GATEWAY REVIEWJustification Assessment

Purpose: To outline the planning proposal, the reasons why the original Gateway determination was made and to consider and assess the request for a review of a Gateway determination.

Dept. Ref. No:	GR 2019 FAIRF 001 00			
LGA	Fairfield City Council			
LEP to be Amended:	Fairfield Local Environmental Plan 2013			
Address/Location:	Cabramatta Town Centre East – Land bounded by Fisher Street, Broomfield Street and Cabramatta Road East, Cabramatta			
Proposal:	cont	The planning proposal (Attachment A) seeks to increase the development controls for land within the eastern portion of Cabramatta Town Centre by amending the Fairfield Local Environmental Plan (LEP) 2013 as follows:		
	 increase the maximum building height for land within the site from 14m to up to 48m (approximately 15 storeys) (note: this was amended by Gateway Condition 1 and is the subject of this review);

Figure 3: Proposed redevelopment stages.

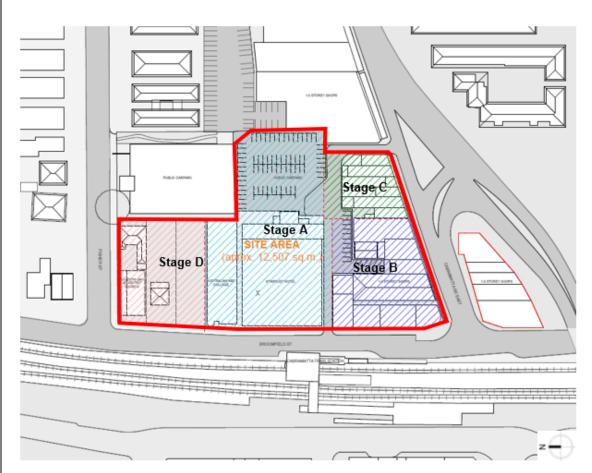
The site is proposed to be developed in four stages (i.e. stages A to D) as shown in Figure 3, with corresponding development controls. A summary of the proposed development controls for each development stage is provided in Table 1.

Figure 10: Council-endorsed heights.

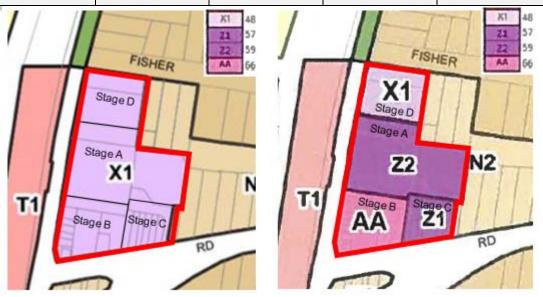
A comparison of the two proposed maximum building heights is provided in Table 2 and Figures 10-11.

The Department considered that the visual impact of an additional four storeys (i.e. 19 storeys compared to 15 storeys) on the corner of Cabramatta Road East and Bloomfield Street would be minor from the street level and the surrounding public domain, as demonstrated by Figure 12 and 13.

Further, there was no justification, or study, provided by Council to support the blanket 48m building height for the site. In addition, the blanket building height of 48m and the identified FSRs of 2.5:1 to 3.85:1, 4:1, 6.1:1 and 6.45:1 for the site are not considered to be compatible. The built form outcome of the proposed development based on these development standards could result in an entirely different building compared to the version assessed by council officers, the Fairfield Local Planning Panel, and the independently appointed urban designers. The Gateway determination concluded that the implication of this may be a development with larger floor plates that has greater building mass when viewed from the street.

Taking these matters into consideration, the Department issued a gateway determination that required Council to Council amend the proposed maximum building height to be consistent with the heights originally assessed and supported by council officers and the Fairfield Local Planning Panel, i.e. a maximum building height of part 48m (approx. 12 storeys), 57m (approx. 16 storeys), 59m (approx. 16 storeys), and 66m (approx. 19 storeys).

Figure 14: The site in the independent urban design assessment.

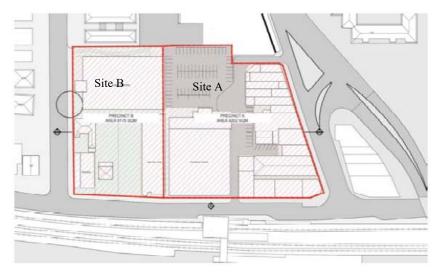
Council's submission was prepared on their behalf by an independent town planning consultant. This report (**Attachment D3**) notes that the previous independent urban design assessment of the planning proposal (**Attachment E2**) by TPG Town Planning and Urban Design assessed two (2) precincts only, a northern precinct (Site A) and a southern precinct (Site B) unlike the 4 precincts proposed under Gateway Determination planning proposal. The controls identified for Site B was a maximum height of 45m and FSR of 3.15:1. Whilst Site A was allocated a maximum height of 72m and FSR of 5.2:1.

Council contends that the original urban design assessment also identifies that to reduce the impacts on neighbouring properties, especially to the south of the site, a reconsideration of building height and distribution of massing is warranted to ensure that the proposal does not unfairly impact on the future solar access and development potential to properties to the south.

Accordingly, the report at **Attachment D3** contends that the Gateway Determination should be altered to require that prior to the public exhibition, Council is to revise the planning proposal, where required, to apply a maximum building height of 48m (approximately 12 storeys to Stage D) and 57m (approximately 16 storeys to Stages A, B and C) across the site.

Figure 16: Redevelopment of 144–158 Cabramatta Road East

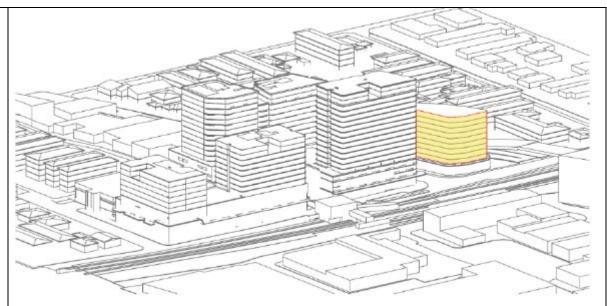
Under Fairfield Local Environmental Plan 2013, this parcel has a maximum FSR of 2.2:1 if the building incorporates between 10 to 50% residential accommodation and a maximum height of 14m. The proponent prepared a concept for a 10 storey building based on the hypothetical upzoning of the site. This building is shown in Figure 16 relative to the subject site.

The proponent report finds that concept 10 storey building is capable of achieving solar access required by the Apartment Design Guide of 2 hours to a minimum 70% of dwellings with the proposed built form outcomes on the subject site. The proponent also tested a 6 storey building with the same finding that solar access can be achieved.
